**CITY OF LEWISTON
PLANNING BOARD MEETING**
Monday, June 25, 2012 – 5:30 P.M.
City Council Chambers – First Floor
Lewiston City Building
27 Pine Street, Lewiston

TO: Planning Board
FROM: David Hediger, City Planner
DATE: June 21, 2012
RE: June 25, 2012 Planning Board Agenda Item IV(a)

An application by Sebago Technics, Inc. on behalf of Parallax Partners, Inc. for the construction of a 90-113 room hotel located at 15 Lincoln Street.

Field Variance Maps
 FVR# II-17-00012
 Map: S7-17-22

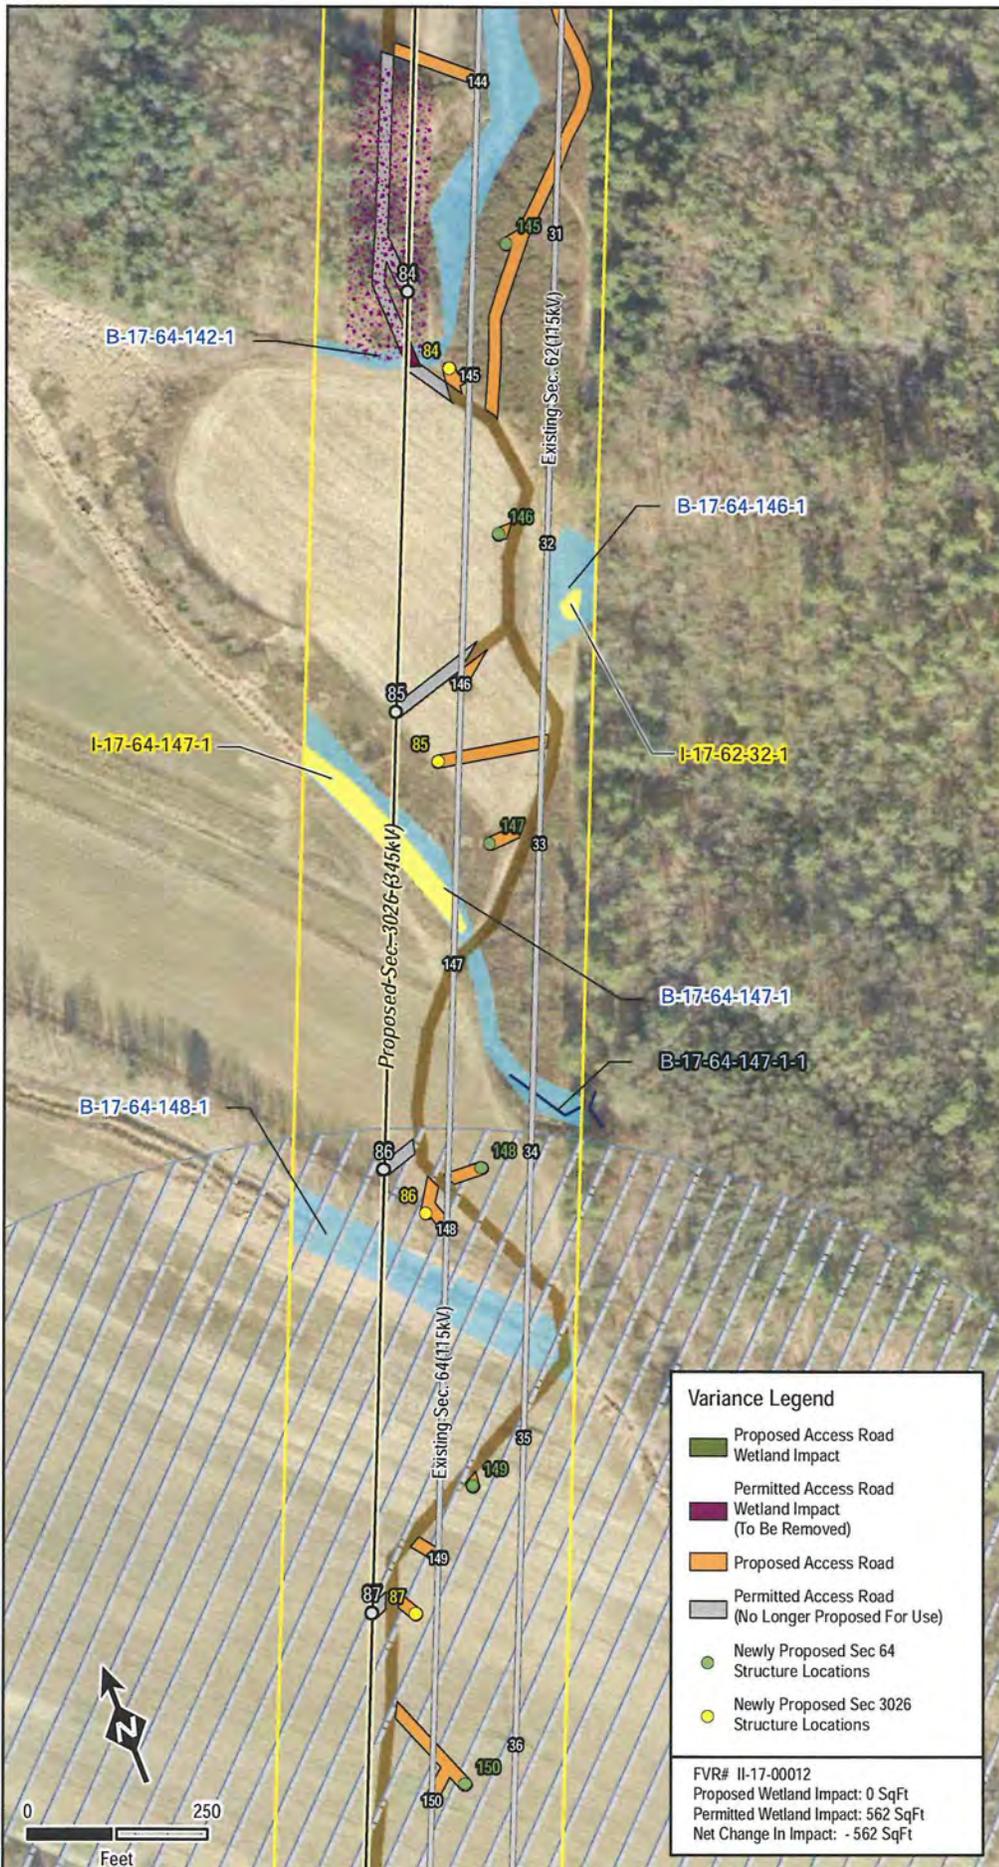
This field variance request seeks approval to relocate multiple structures on the Section 64 and Section 3026 transmission lines in an area located between Cotton Road in Lewiston and the Auburn/Durham town line (see attached map set). The proposed change is the result of an engineered solution designed to comply with a Maine Public Utilities Commission Order and a confidential settlement with an abutter. The new structure locations and access to them are all located within upland areas. The change results in an overall reduction of 562 square feet of wetland impact.

3PI Notes: This request involved moving some recently installed structures across the Sec. 64 line, due to a PUC order. There will be no additional wetland impact occurred by this design change. Str. 64/154 is to be removed by hand-cutting and cable sliding out to PAR.

FVR# II-17-00012
 Proposed Wetland Impact: 0 SqFt
 Permitted Wetland Impact: 562 SqFt
 Net Change In Impact: - 562 SqFt
